CWSP SYSTEM HARDENING FIELD SCOPING DOCUMENT

PM: 35217268	Project Name: SH - BUCKS CREEK 1101 CB	
Notification: 120047659	Region: Northern	City: Rock Creek
Project Manager: [REDACTED]	Division: North Valley	County: Plumas

- A) **Project Area** – Google Earth Image with Circuit and HFTD Tier 2 &3 Overlay

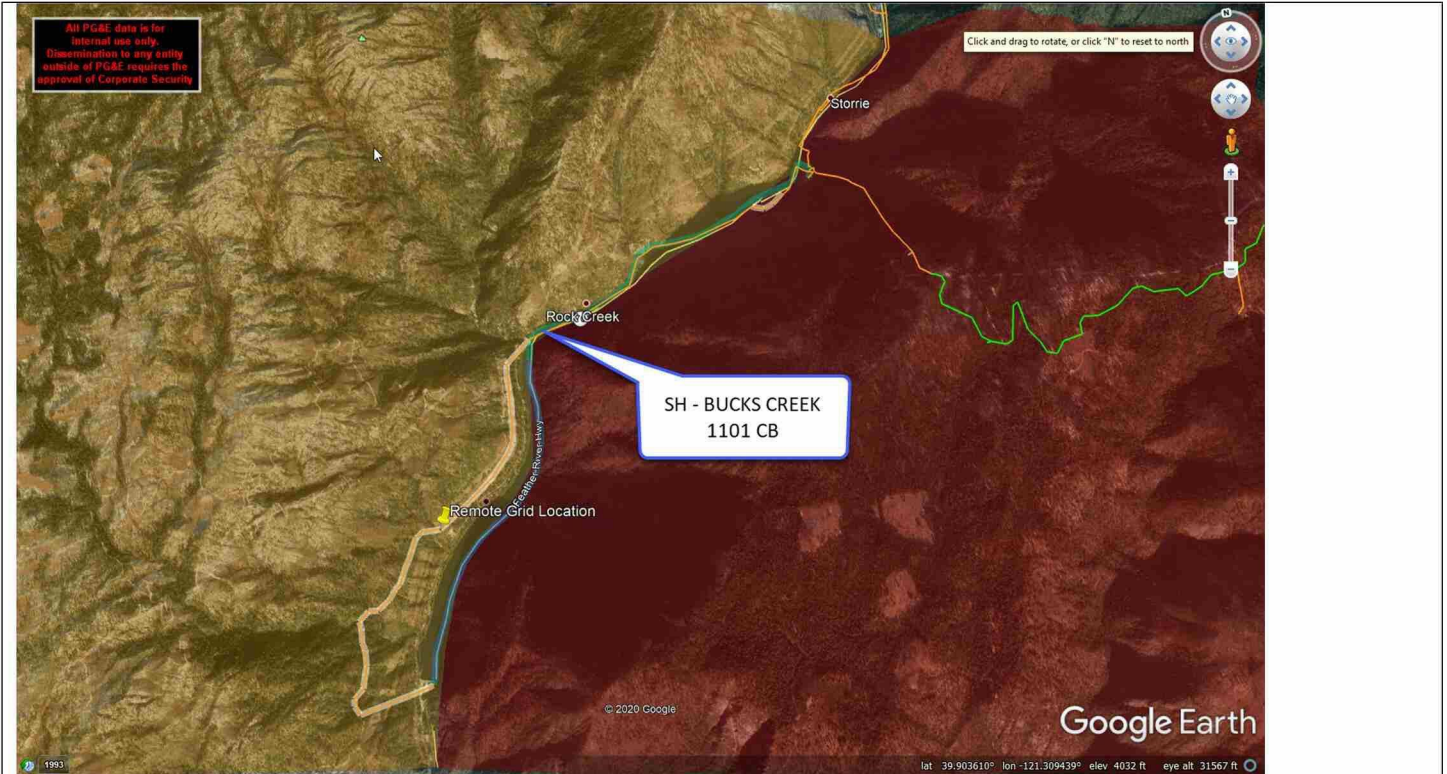
Location, Fuel Types and Population Density:

- The Bucks Creek 1101 project is in Plumas County. The project originates near the community of Storrie and continues westerly along Highway 70 and the North Fork of the Feather River down to the Cresta Powerhouse.
- Fuel types are consistent with moderate to heavy brush and mixed conifer, however the general area has been heavily fire scared and the fire scar areas are intermixed with a significant amount of standing and down dead fuel.
- The community of Storrie is at the eastern end of the project has only a few residents. The Feather River Canyon area is sparsely populated. Larger communities exist much farther to the east in Quincy, Plumas County and west in Concow, Butte County.

- This area has significant fire history directly impacting the project area. A 20 year look back at area fire history includes, the 56,000 acre Storrie fire (2000), 8,000 acre Poe fire (2001), 1700 acre Highway 70 fire (2001), 50,000 acre Butte Lightning Complex (2008), Canyon Complex (2008), 30,000 acre Chips Fire (2012), 154,000 acre Camp fire (2018) and the 320,000 acre North Complex 2020 all burned within the Feather River Canyon.

- Not all the fires were directly in the project footprint area; however, they show that this area is prone to significant, large fire history due in large part to steep, rugged, inaccessible terrain and periods of strong wind.

- The Feather River drainage is prone to daily diurnal winds and strong north/Diablo wind events at various times of the year, but most notably during the fall period when fuels are at their driest. These conditions have resulted in the area being affected routinely by PSPS events and has also resulted in many large, devastating fires originating in the Feather River drainage.
